**RE: COVER LETTER AND PROJECT NARRATIVE
Preliminary/Final Land Development Plan for MESA Substation
Mount Joy Township - Lancaster County, PA
HEI Job No. 251195-001**

**RE: Modification Request Letter - REVISED
MESA Substation
Mount Joy Township - Lancaster County, PA
HEI Job No. 251195-001**

PROJECT TITLE
PRELIMINARY / FINAL LAND DEVELOPMENT PLAN FOR MESA SUBSTATION
MOUNT JOY TOWNSHIP, LANCASTER COUNTY, PENNSYLVANIA

SHEET TITLE
EXISTING CONDITIONS AND DEMOLITION PLAN

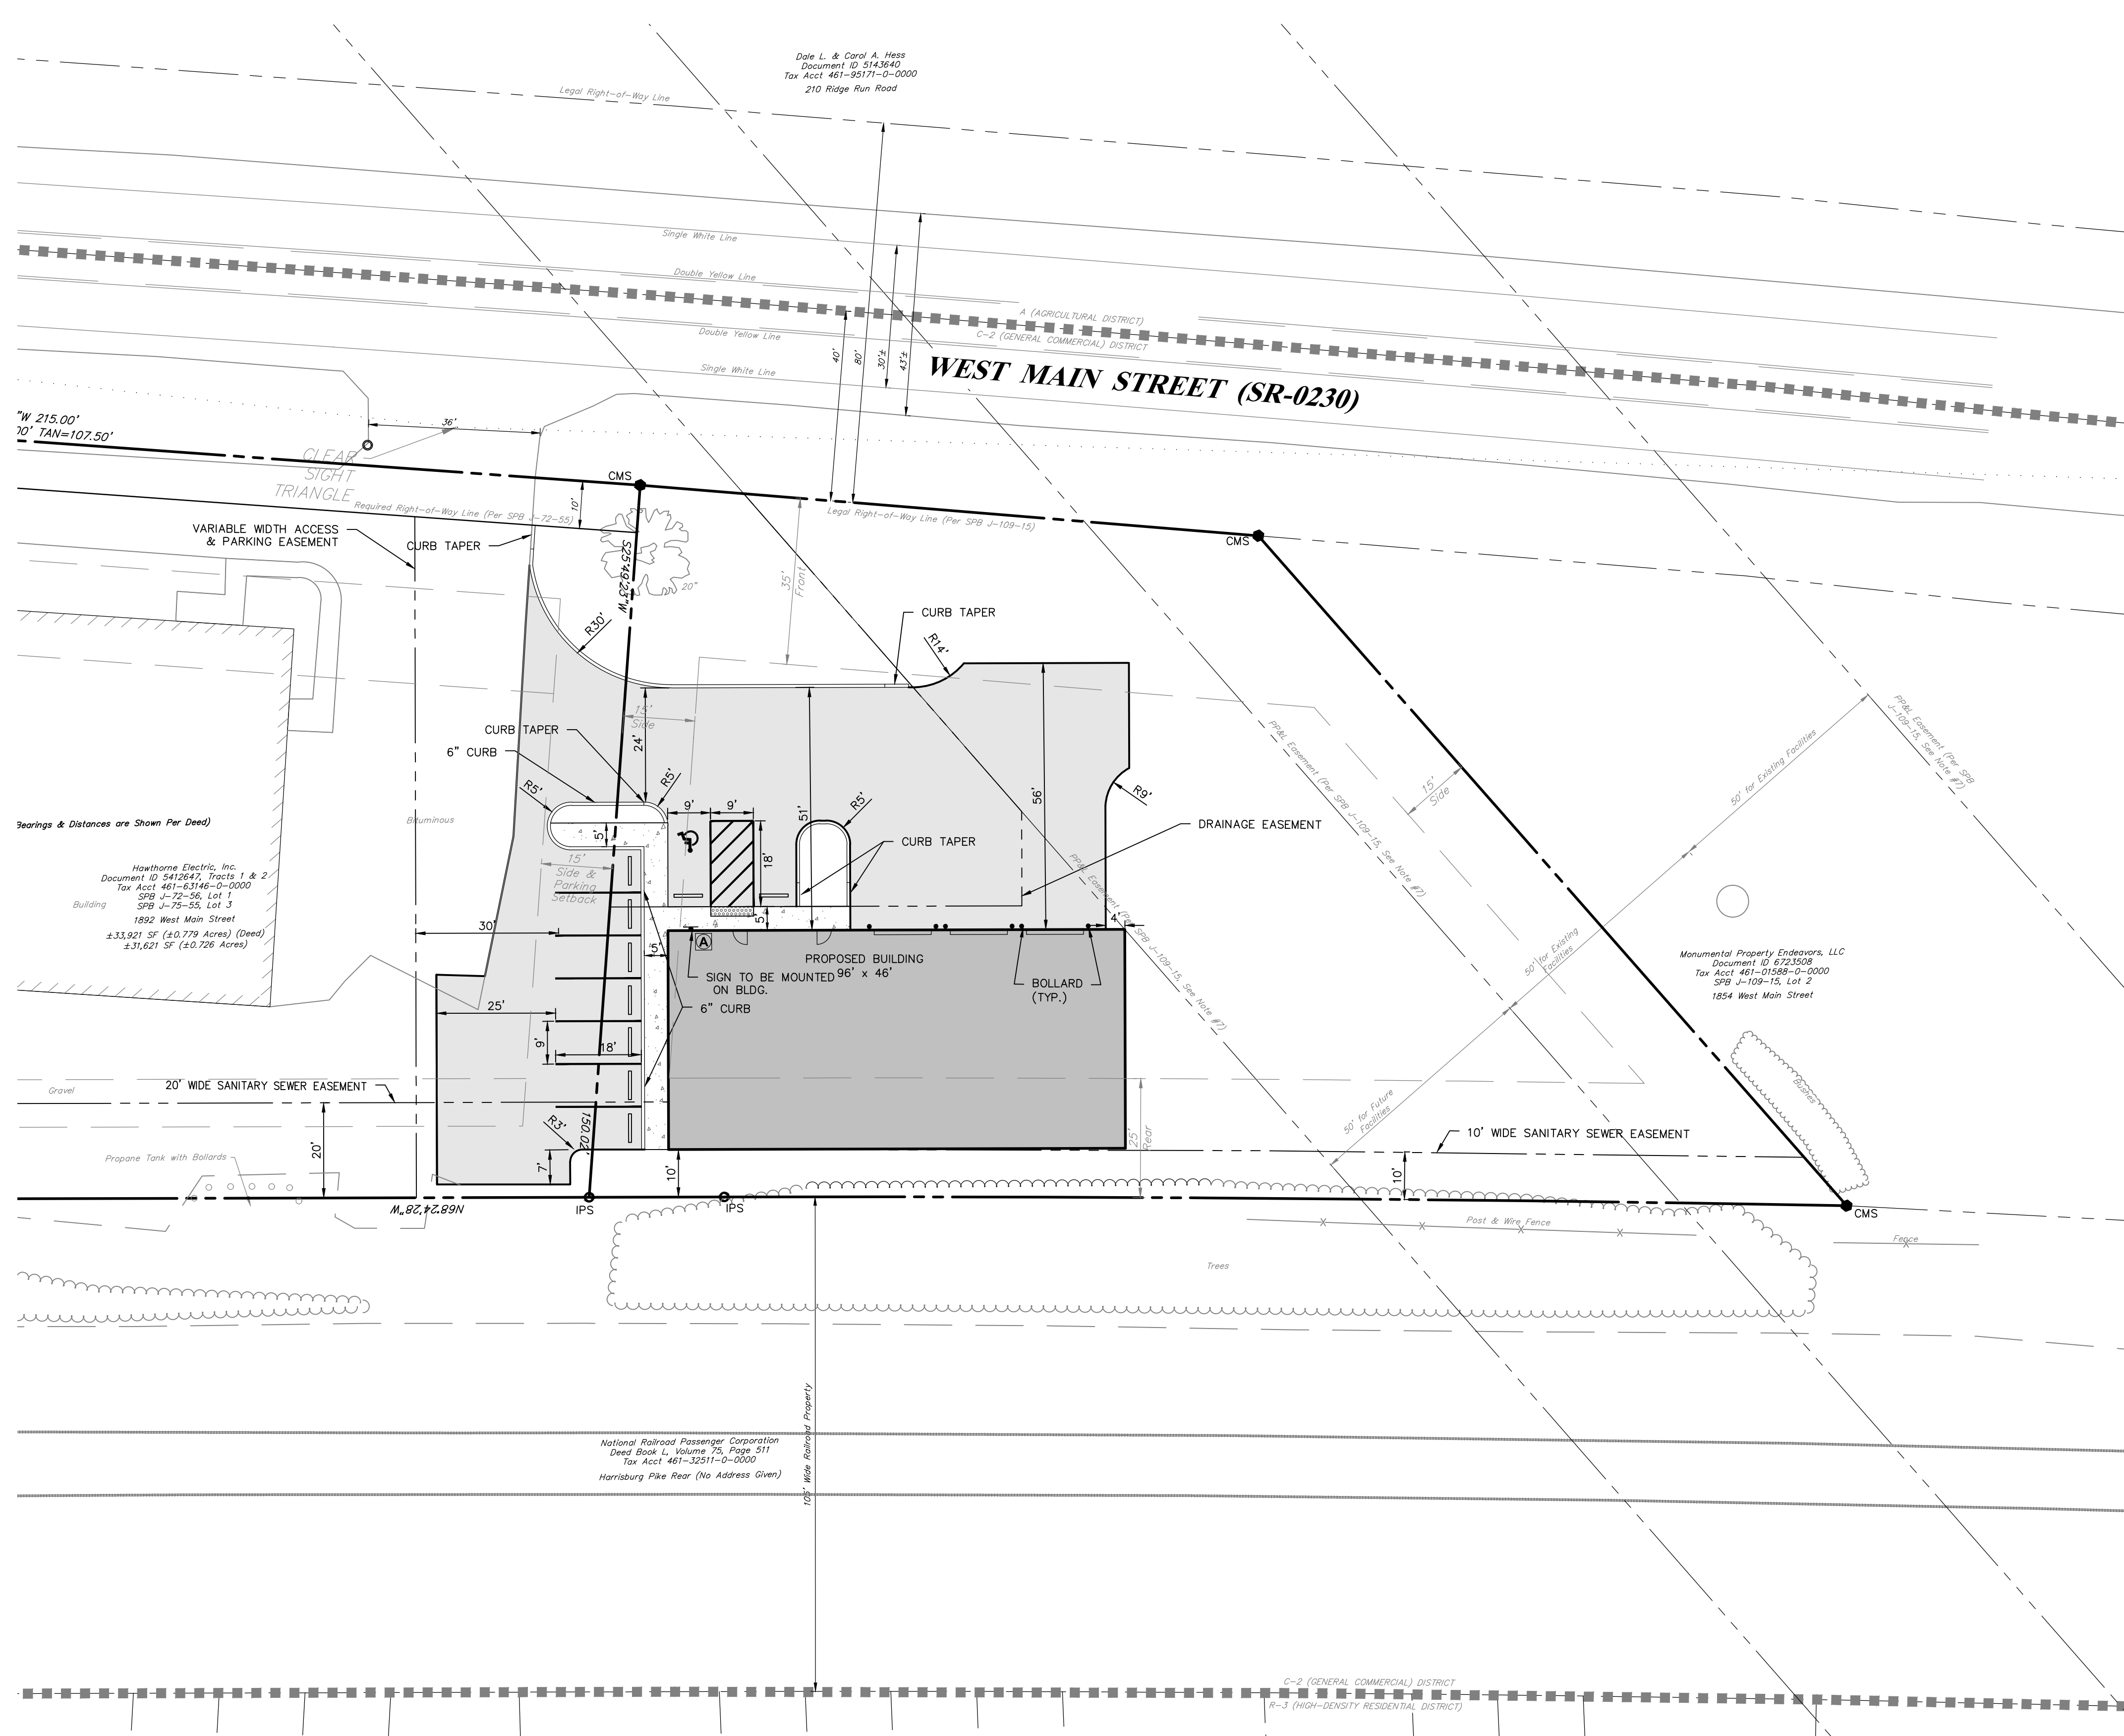
1892 West Main Street is provided with sewer service through an on-lot sewage disposal system which is proposed to be removed. Sheet 3 of the Plan states that the existing drainfield and septic tanks will be removed in accordance with all applicable Department of Environmental Protection regulations. The Sewage Enforcement Officer should be allowed to confirm that the on-lot sewage disposal system serving 1892 West Main Street has been properly removed or abandoned.

6. The plans shall be signed and sealed by a registered engineer, surveyor or landscape architect (119-31.A(5)).
7. The Rural zoning district boundary line label shown on Sheet 3 shall be corrected to Agricultural (119-31.B(9)).
8. Bearings and distances shall be provided for the Hawthorne Electric tract boundaries via survey (i.e. deed plot is not permitted) (119-31.B(17)).
9. Existing features within 200 feet of the subject tract shall be shown on the plans (119-31.C(3) & 113-43.I(5)). The applicant has requested a waiver of this requirement.

SHEET TITLE
GRADING AND UTILITY PLAN

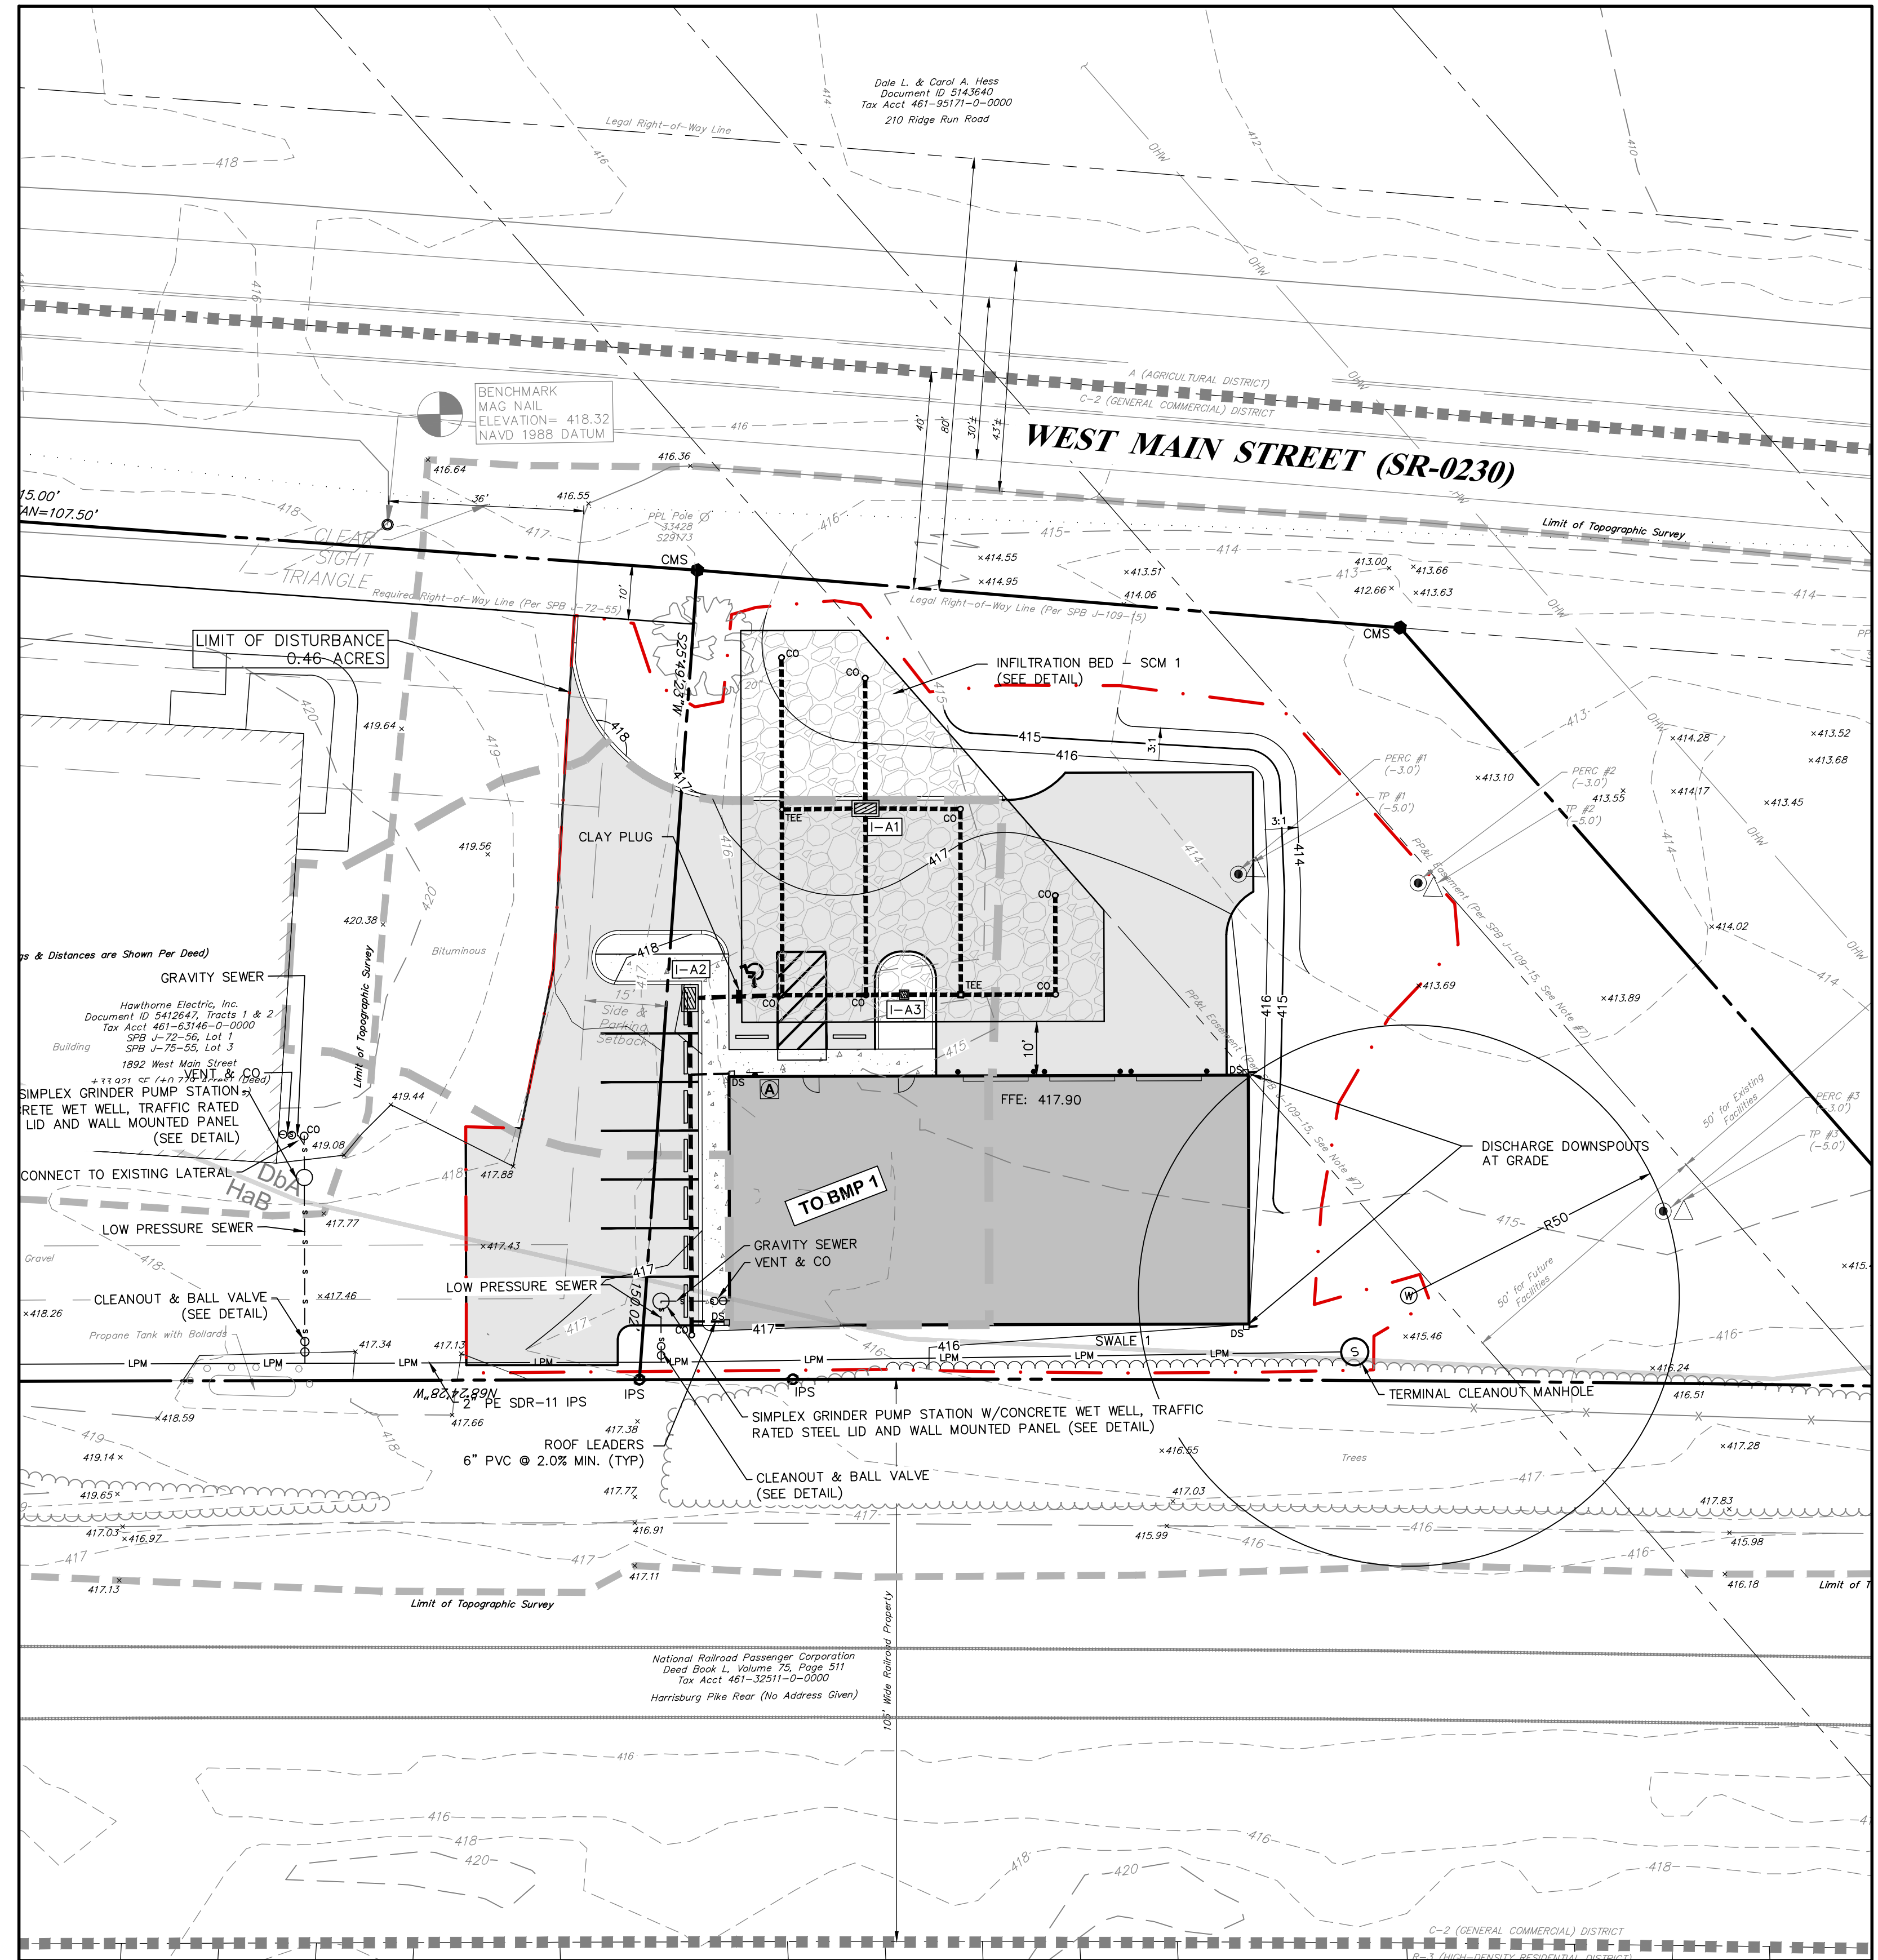
It appears from Sheet 6 of the Plan that all storm water management facilities (i.e. infiltration bed, pipes, and inlets) are located on the MESA lot. However, those storm water management facilities serve the impervious surface coverage to be constructed on both lots. The Storm Water Management Agreement must include both lots.
